Re: Public Version of the Comments on Vectren's 2016 Integrated Resource Plan

Report on Vectren 2016 IRP

Submitted to the IURC on April 17, 2017

Figure 4. Strategist annual cumulative present value of selected portfolios—
CONFIDENTIAL

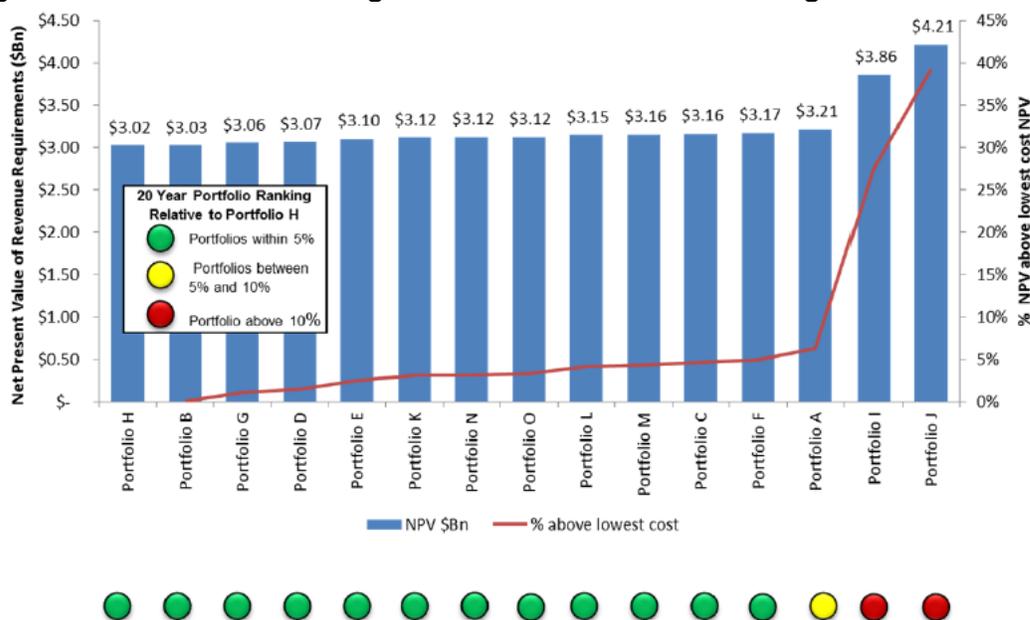
While Figure 3 presents the portfolios' 20-year NPV, Figure 4 shows the total cumulative present value of each selected portfolio in each year over a 20-year period. The 2036 value for each of these portfolios shows a similar trend to Figure 3 (above) – Portfolios I and J are substantially more expensive than Portfolios K, L and M.

What Figure 4 makes obvious, though, is that the 20-year NPV values obscure the fact that cost differences between the portfolios only arise starting in 2024; prior to that, the portfolios are very similar in cost. This is significant because one of the biggest differences between Portfolios I and J and Portfolios K, L and M in the initial seven years of each plan is the level of energy efficiency being implemented.

Figure 16. Vectren 2016 IRP Figure 7.16—IRP Portfolio Balanced Scorecard

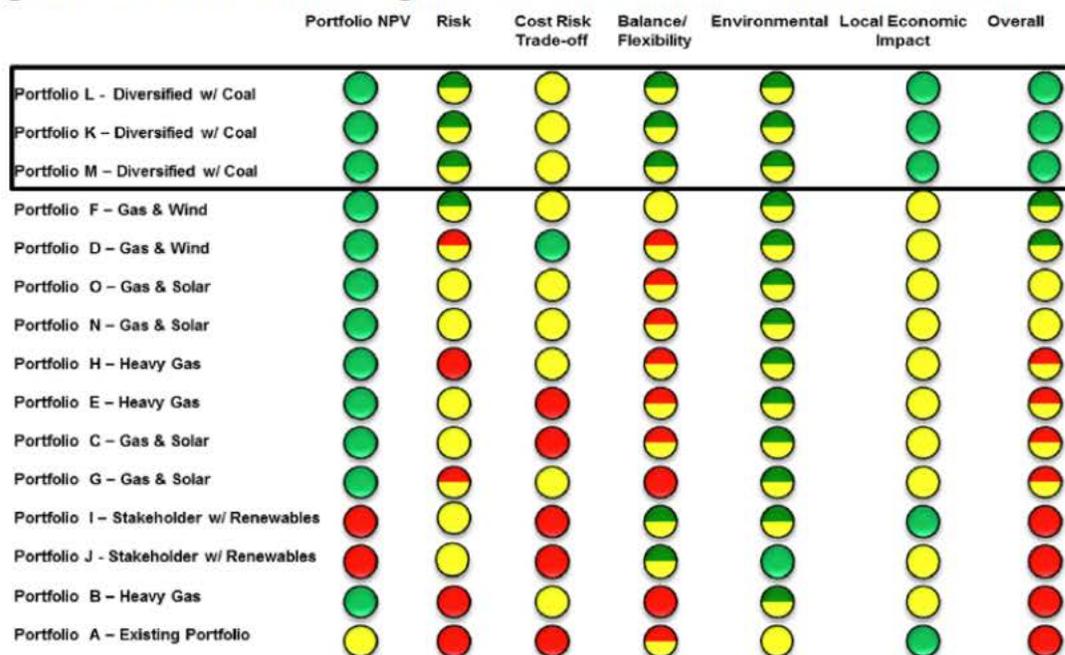
To better understand this methodology, we replicated Vectren’s scorecard metric and weighting system (see Figure 17 for a direct reproduction of Vectren’s six main metrics and overall metric using our formatting, here presented in a neutral order). Figure 17 shows Vectren’s red, yellow, and red scores with black text and its red-yellow and green-yellow scores with yellow text. The numbers shown are ranks, 1-5, for these colors: red (worst) = 1; red-yellow = 2; yellow (caution) = 3; green-yellow = 4; and green (best) = 5.

A comparison of Figure 18 to Figure 17 raises several questions:

- If these metrics were not equally weighted (as appears to be the case judging from the discrepancies between Figure 17 and Figure 18), on what basis were they weighted and why?
- Why has Vectren chosen to rerank the overall metric results in a manner which certainly accentuates and perhaps overemphasizes the differences between them?
